INSTRUCTIONS

LiquiCal/Omnitrol Control Circuit Board

Applies to the conductivity controlled bleed feature on all Omnitrols and LiquiCals manufactured after 9/1/98.

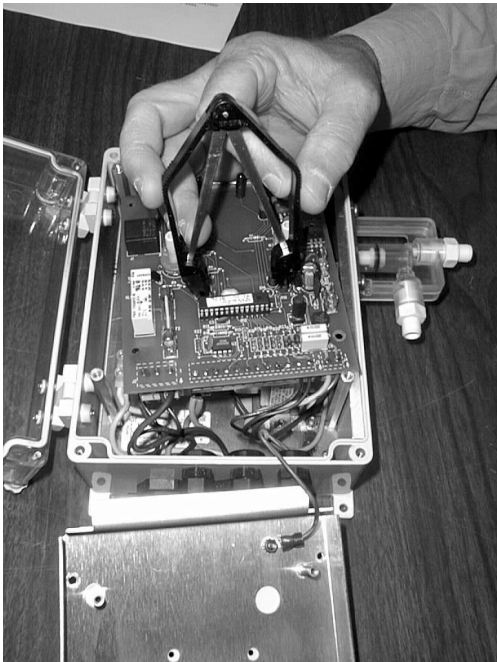
The bleed control feature found in Operating Modes 1,2,7 & 8. has been found to reflect erratic and erroneous conductivity readings. The "Proof of Delivery" function (Modes 7 & 8) will be eliminated due to software problems.

If you are using Modes 1 or 2, or if you intend to use them, change EPROM on printed circuit board from current version (V1.10 or V1.11) to V2.0. See diagram below. This new software chip will correct the problem associated with Modes 1 & 2. Modes 7 & 8 will no longer be supported. For those using the supplied flow assembly, the chemical injection "T" fitting should be plugged. Locate the chemical injection point downstream from the sample collection point.

Be sure that the half-round impression on the chip is facing toward "U2" label on PCB. Discard old EPROM.

1. Turn off power to unit. Note and write down bleed and feed knob settings.
2. Turn bleed and feed adjustment knobs fully clockwise and mark pointer location on front label. A lead pencil works well. Remove knobs carefully.
3. Remove (4) mounting screws and pull out front panel/PCB assembly from enclosure.
4. Remove (4) screws that hold printed circuit board to panel. Turn PCB over. You will now have access to change the EPROM located on the other side of the printed circuit board.
5. Remove V1.10 or V1.11 software (use suitable EPROM removal tool or pry out with screwdriver). Replace with new chip in the upgrade kit. New chip should read "V2.01."
